**CITY OF STURGEON BAY
HISTORIC PRESERVATION COMMISSION
AGENDA**

1. Roll call.
2. Adoption of agenda.
3. Approval of meeting minutes from March 30, 2022.
4. Consideration of: Roof rail system for Anthony Scimeca located 242 Michigan Street.
5. Adjourn.

To: Historic Preservation Commission
From: Christopher Sullivan-Robinson
Date: Thursday, March 24, 2022
Subject: Application Review – 242 Michigan Street

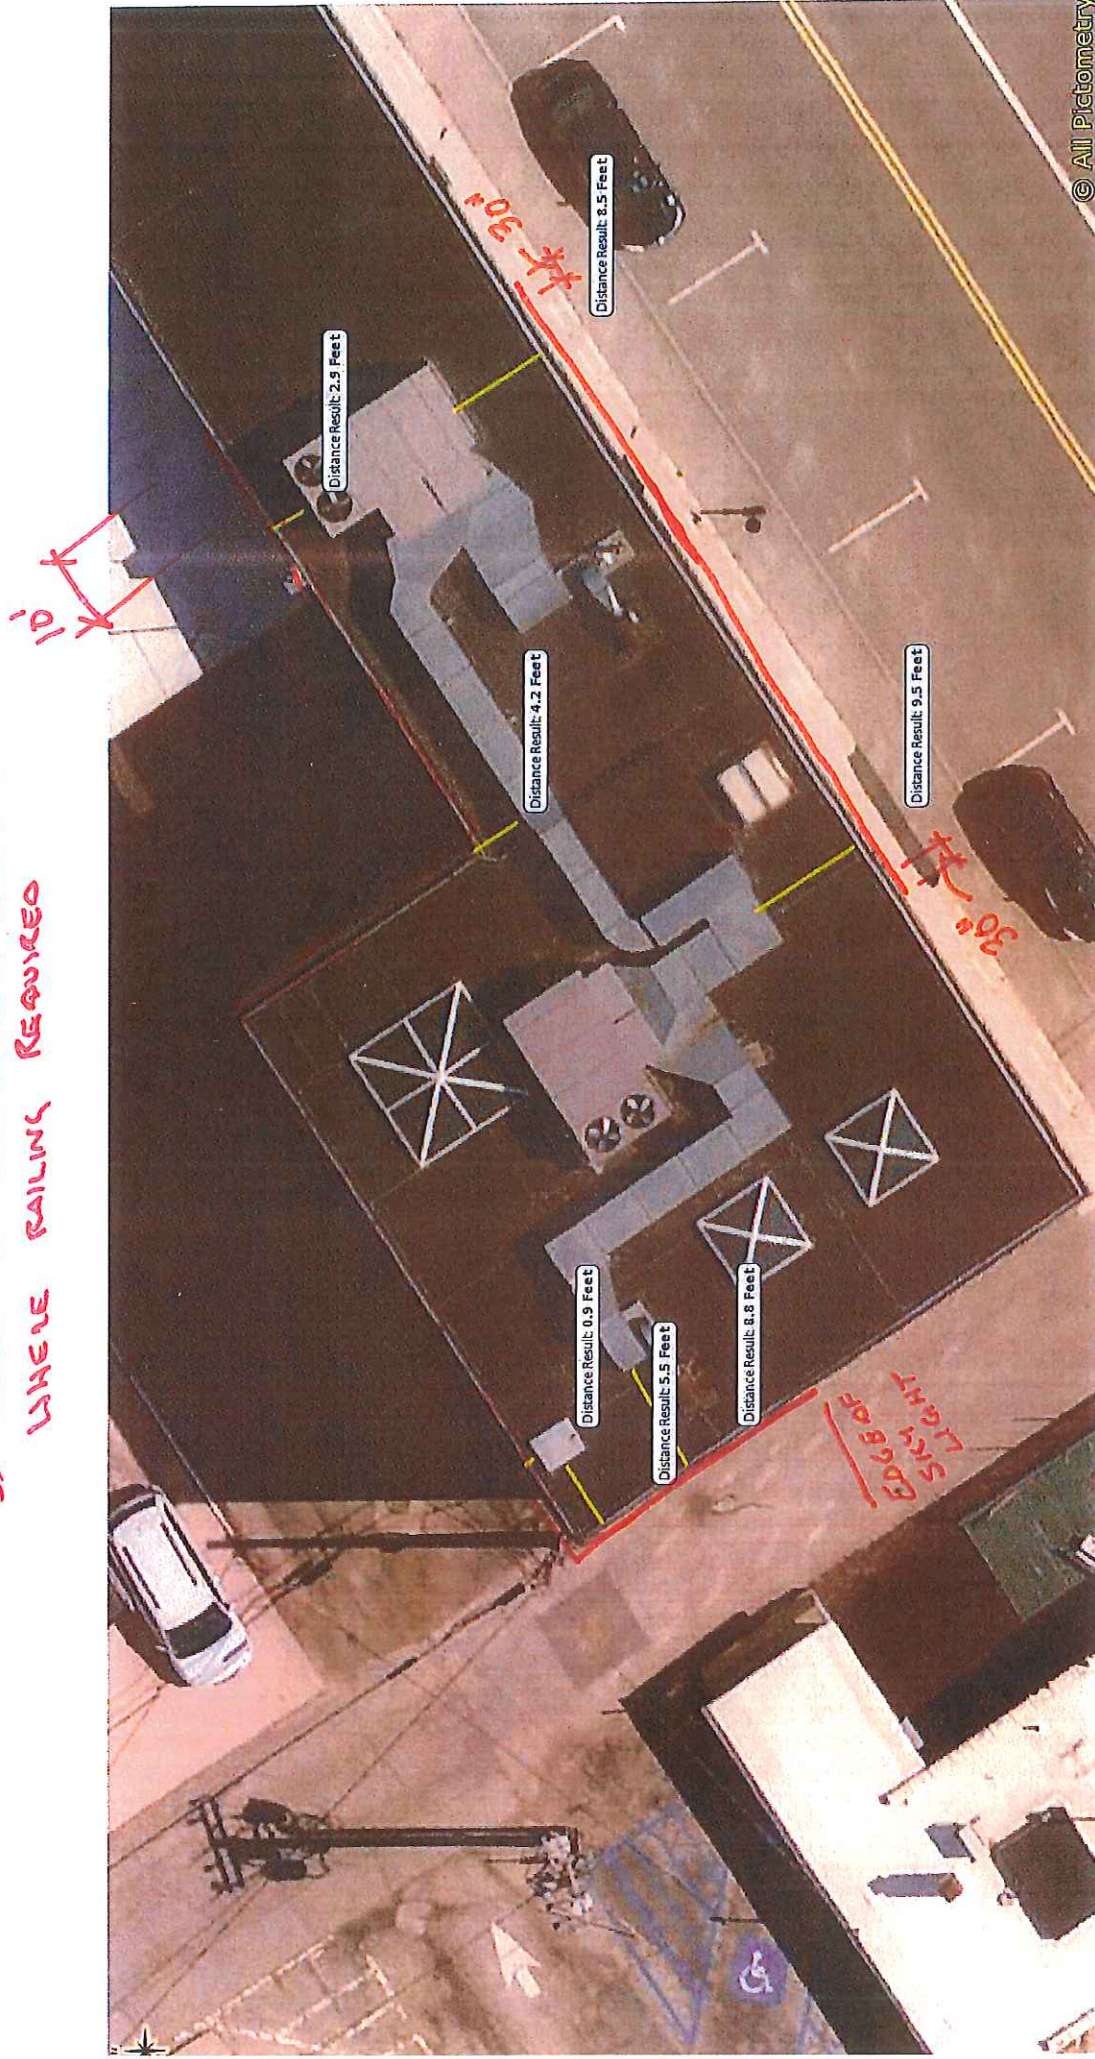
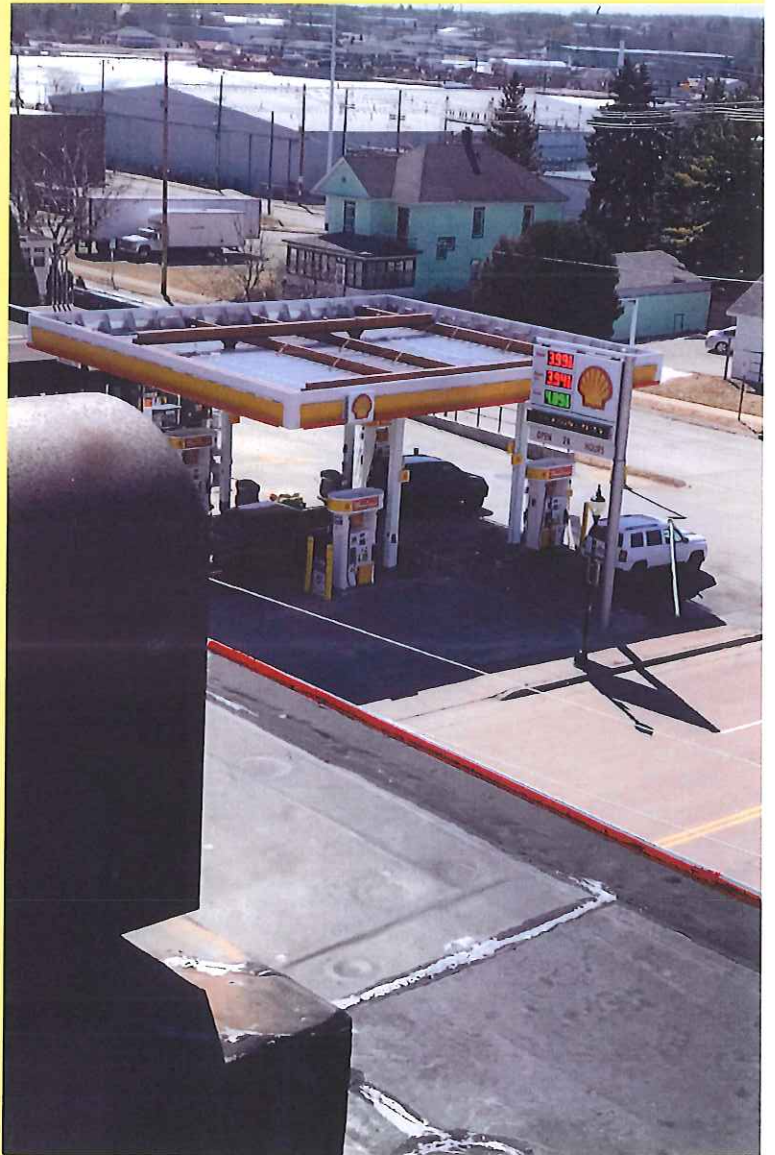
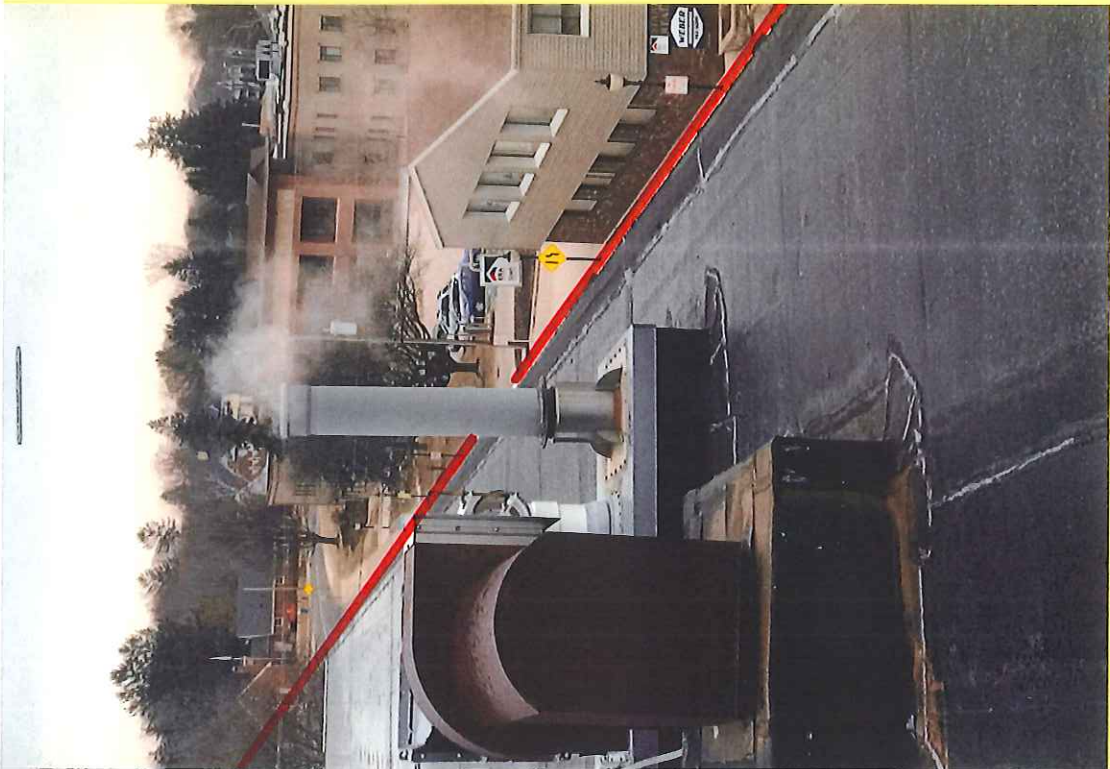
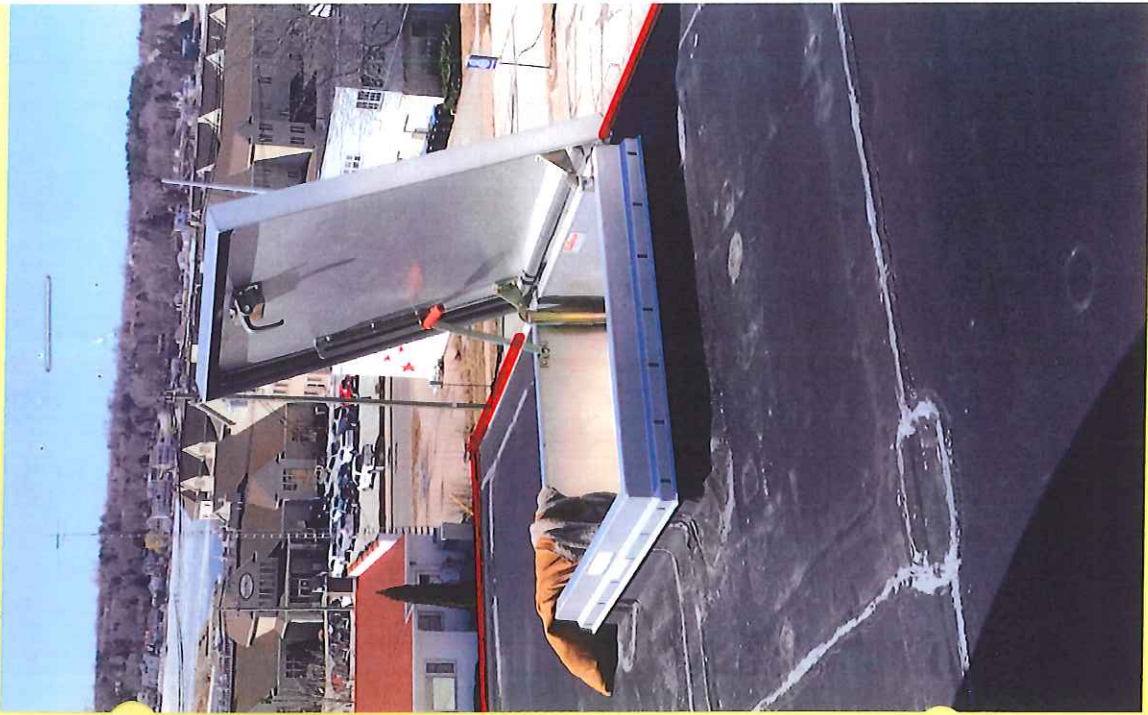
As you will see by the pictures there is no impediment that will stop a person from falling to their death.

Currently, there are areas on the roof that mechanical equipment is within one foot of the edge of the roof.

We request that the entire perimeter of the roof is protected with the attempt to save lives.

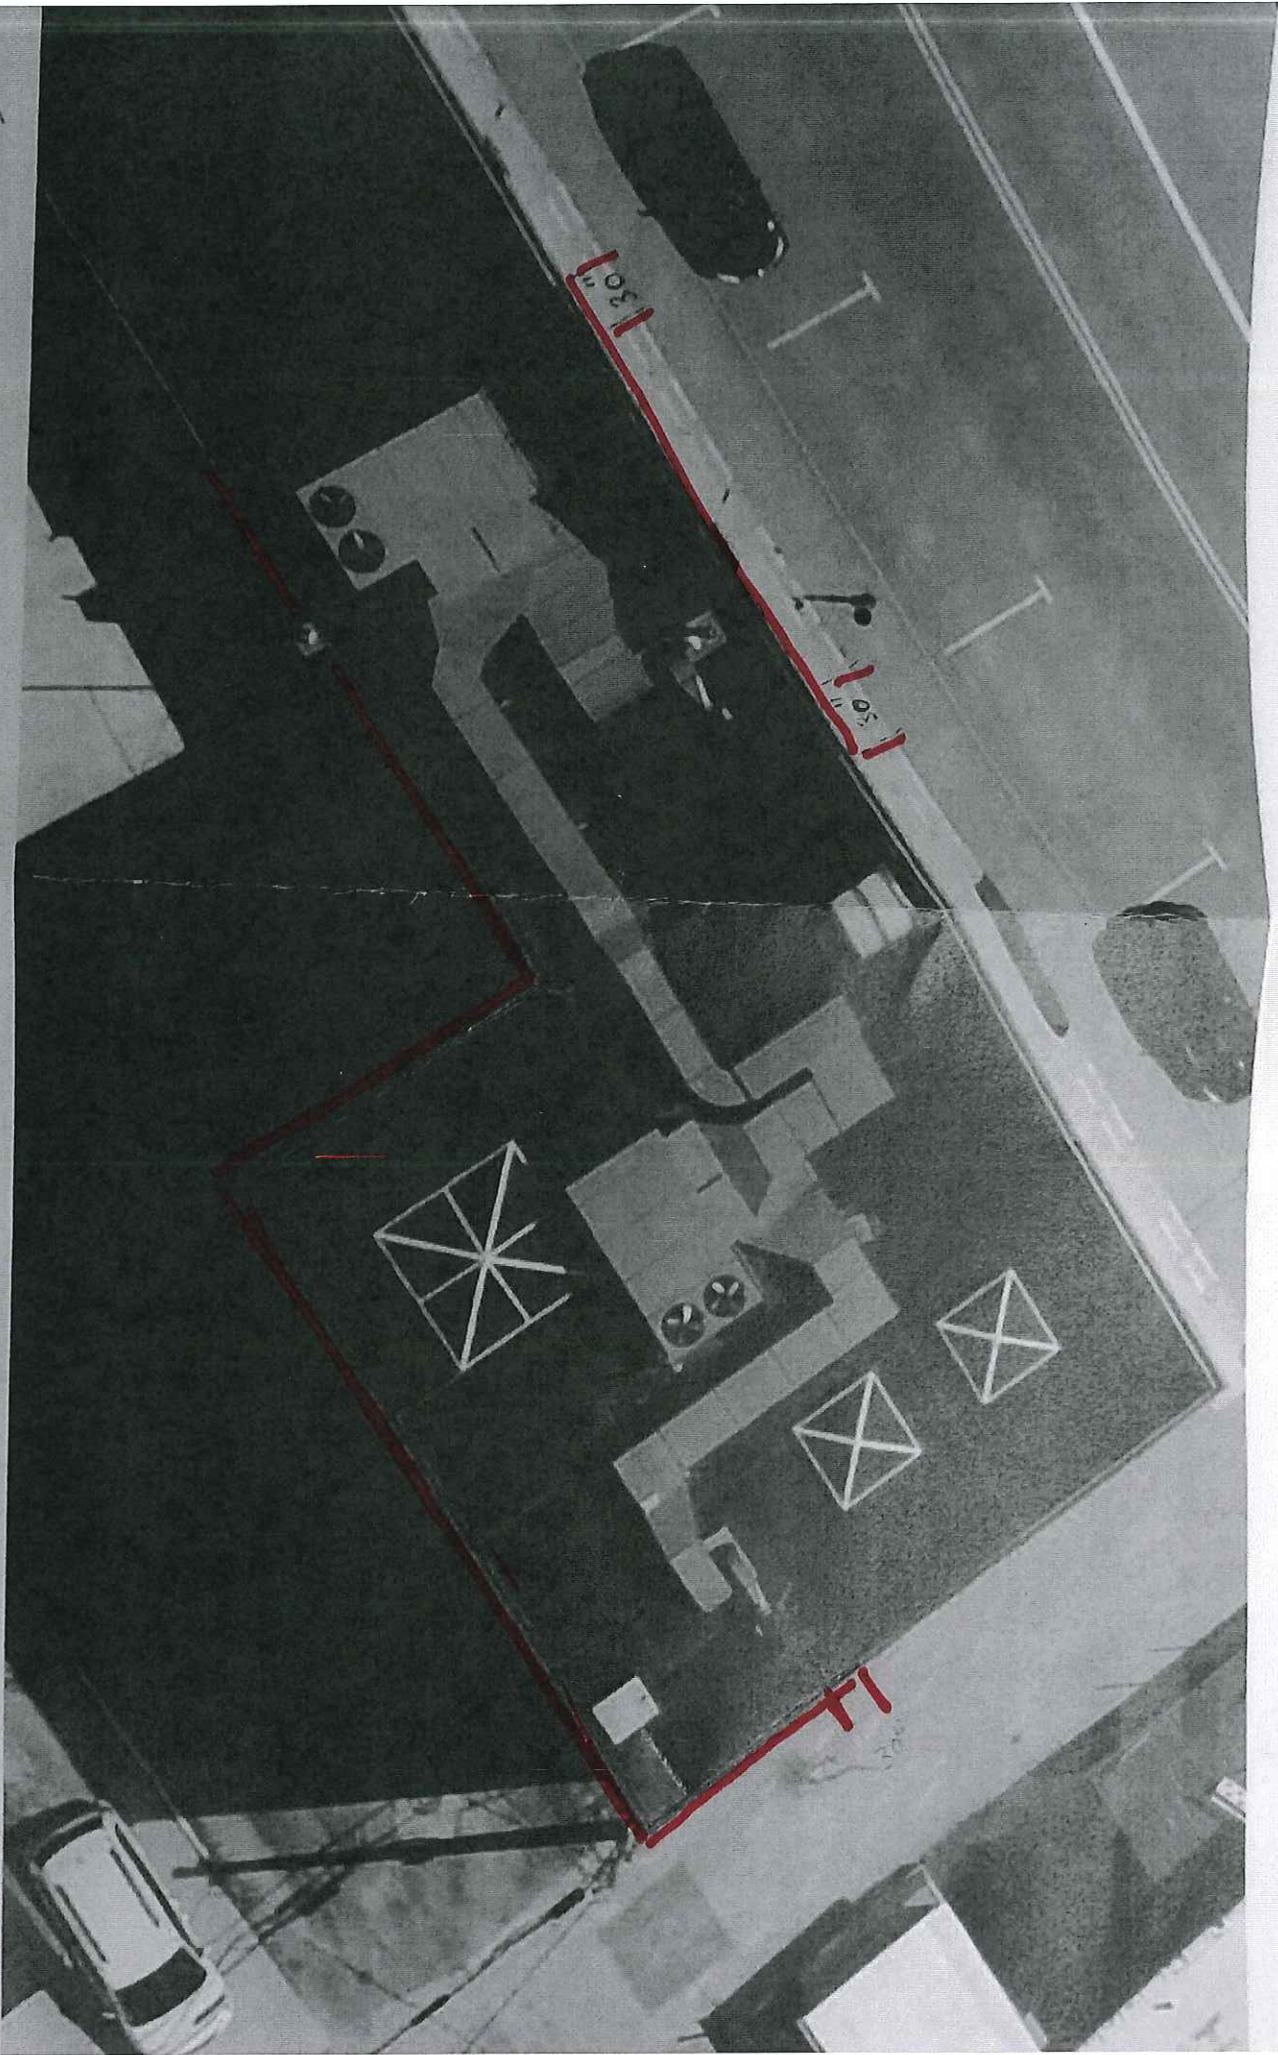
Under the current commercial Building code – 2015 IBC and 2015 IMC (see attached) roof access hatches, walkways and equipment requiring servicing that are within 10 feet of the roof edge, require a 42 inch guard system. For this roof if applying today's code, a 42 inch rail would start 30 inches beyond the east edge of the south end exhaust fan, continue to the SW corner of the building, continue along the west edge of the building past the access hatch, continue along the walking edge to a point 30 inches past the edge of the most northern RTU (roof top unit). A guard would also be

required on the East side - starting 30 inches past the edge of the North RTU and continue 30 inches past the blower fan unit located near the east edge (see plan).

Since there is no building code mandate for the owner to update to the current commercial building codes (unless new rooftop equipment is added, not including direct equipment replacements), it would be the owners choice to install a guard system. If deciding to adopt the guard requirements of the 2015 IBC and IMC, then installation needs to comply with all the minimum requirements - the minimum height, strength and minimum extension past equipment, access hatches and walkways.
